Project Name:	Land at Bayards, Eastergate (Miller Homes)
Document Reference:	091.5016/SVR/3.2
Document Name:	SuDS Verification Report – Area 3
Prepared By:	Samuel Flesher
Checked By:	Meagan Weedon
Approved By:	Jon Soar

Revision Record				
Rev	Date	By	Summary of Changes	Aprvd
1	30/04/2026	SF	First issue (Draft)	MDW
2	01/05/2026	MDW	Second Issue	JFS

- 1.1 This Sustainable urban Drainage Strategy (SuDS) Verification Report – Area 3, has been prepared by Paul Basham Associates on behalf of Miller Homes to support the 'As-Built' verification report to Arun District Council in relation to Land at Bayards, Eastergate.

PBA Drawing No.	Revision
091.5016.0502	C05

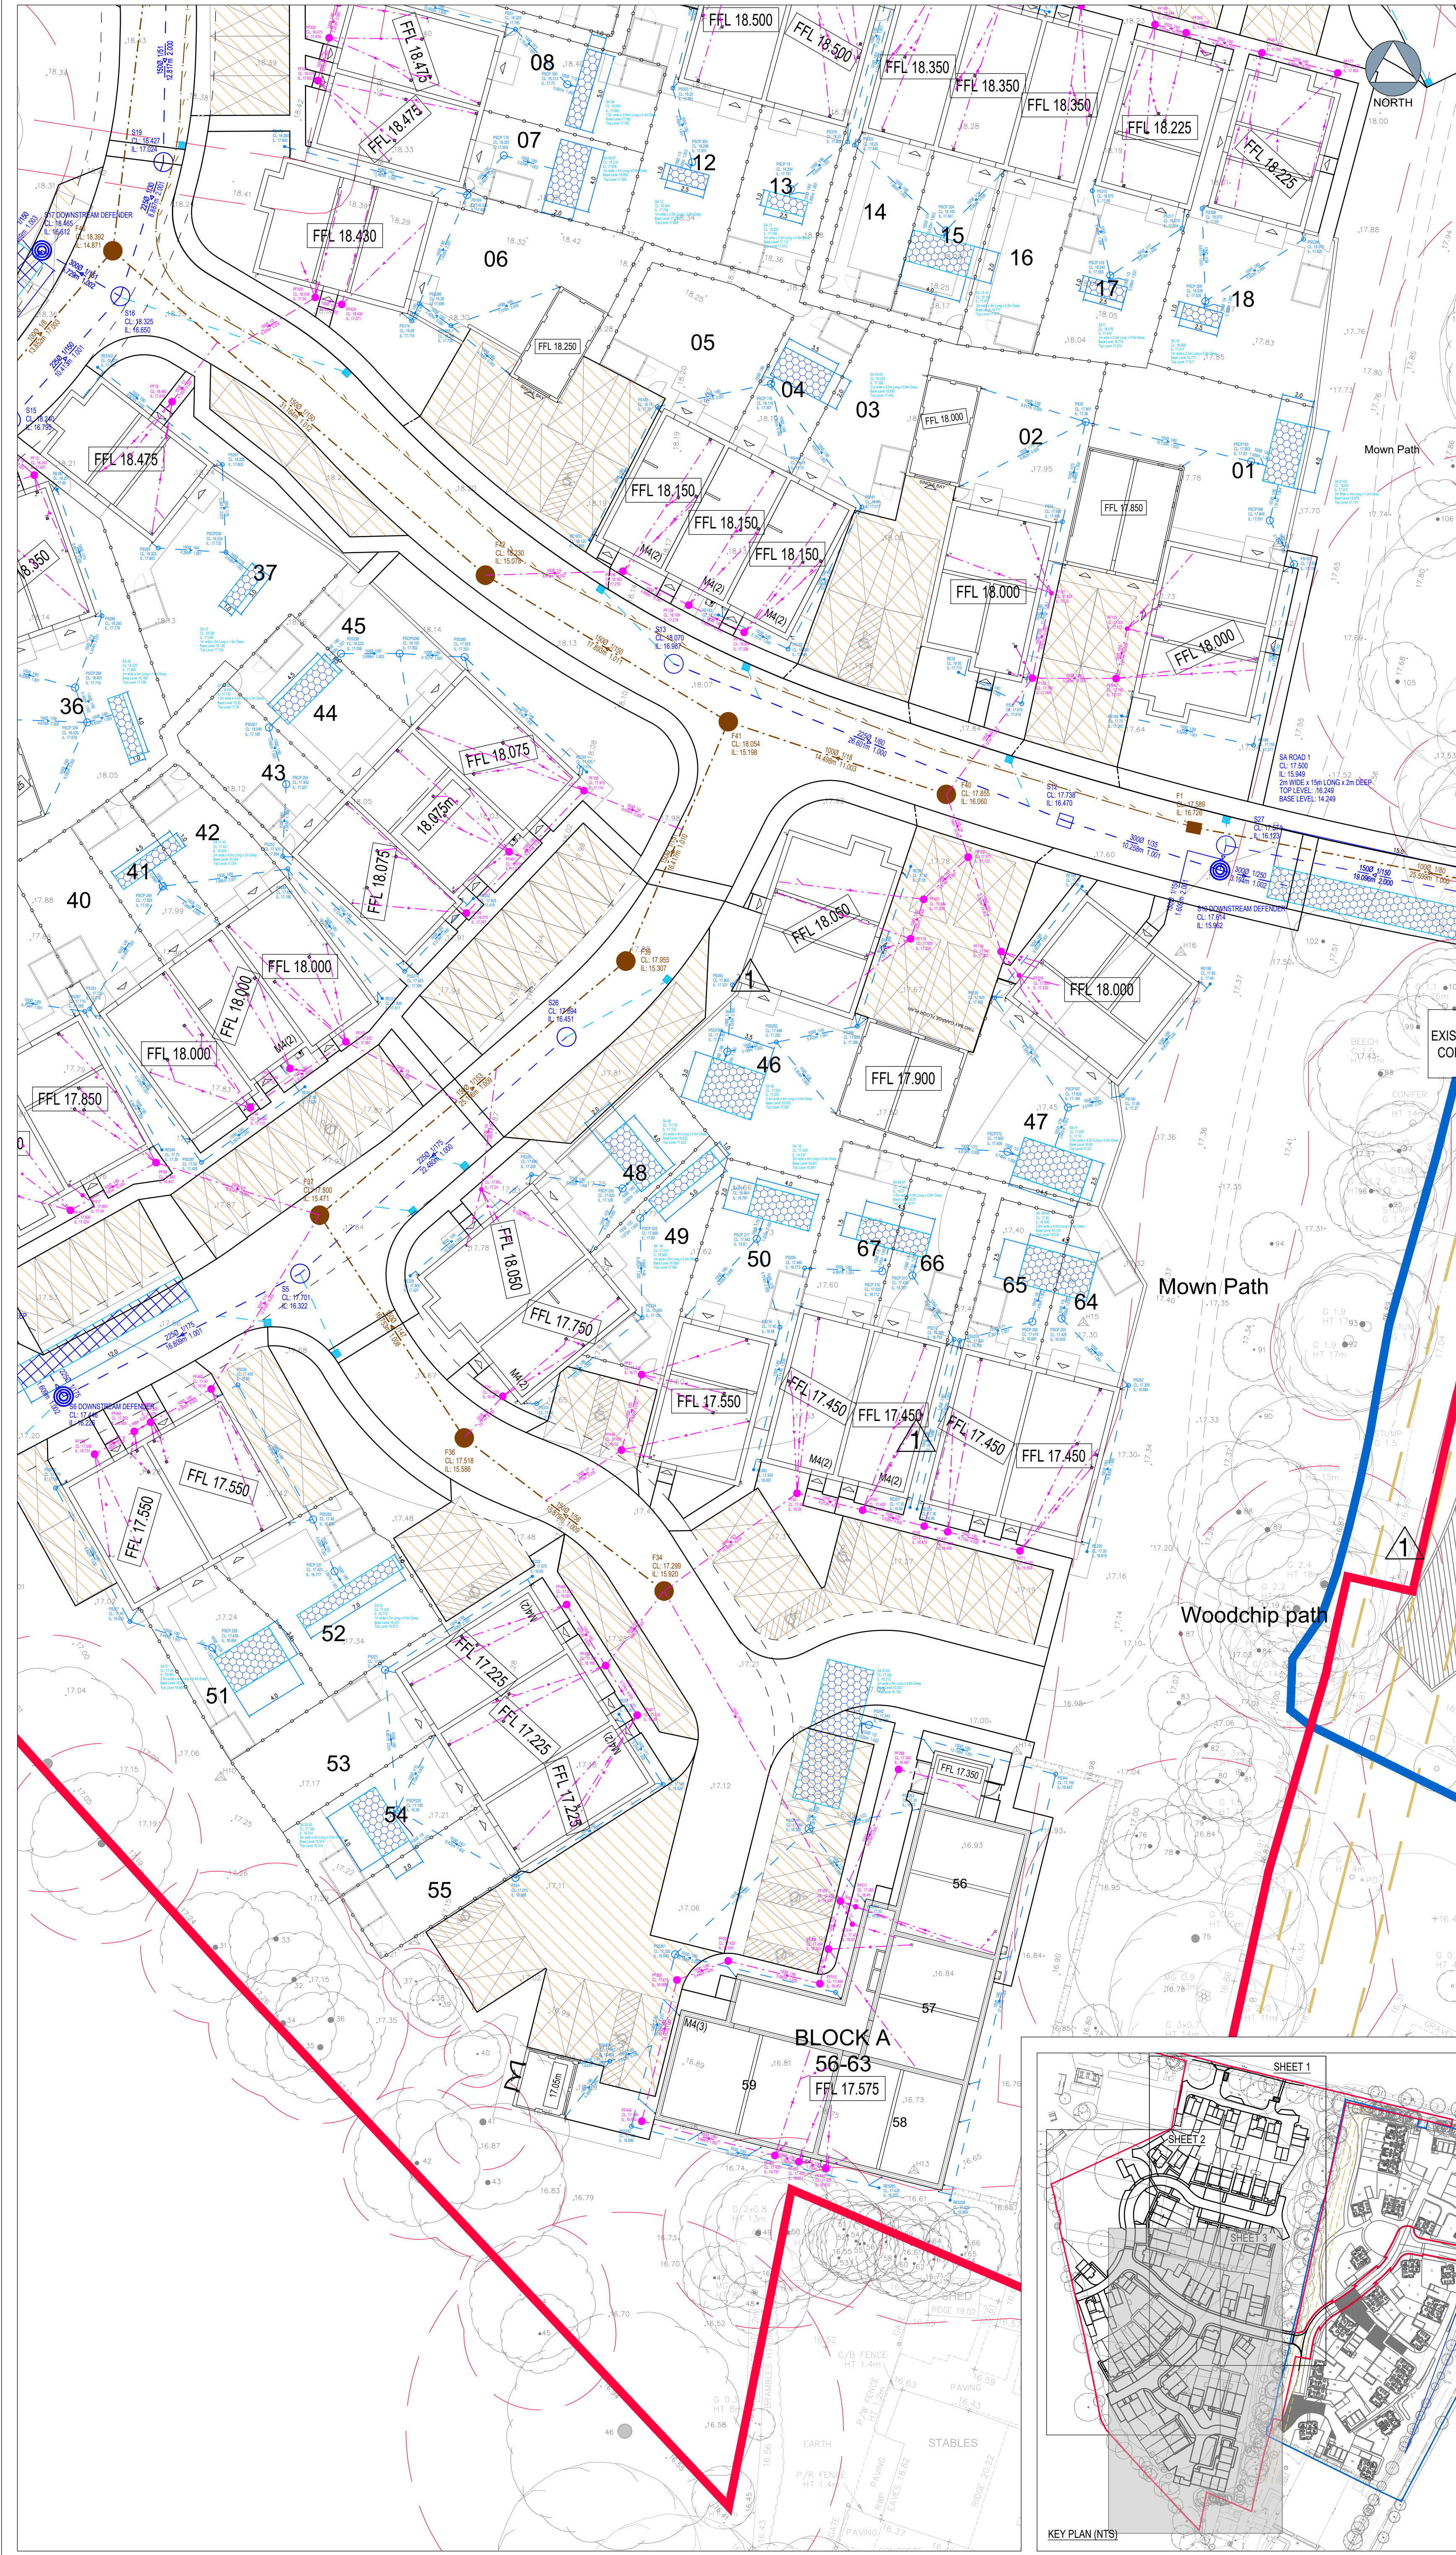
- 3.1 As-Built surveys of the site area and drainage systems have been carried out, these surveys are included as **Appendix C**
- 3.2 These levels have been reviewed against the design levels shown in 091.5016.0501 C08, 091.5016.0502 C05 and 092.5016.0503 C06 the design drawings can be found in **Appendix B**
- 3.3 A tabulated summary of invert levels for chambers constructed within Area 3 is given below.

- 3.4 The comparison between the design and as built levels shown that the invert levels are generally within normal building site tolerances and fall in the correct directions, unless otherwise noted within the comments provided in Table 1 above.
- 3.5 Based on the as-built levels as per Table 1 cross checks of raised invert levels appear to show that no backfalls have been created.
- 3.6 No levels were provided for RE233.
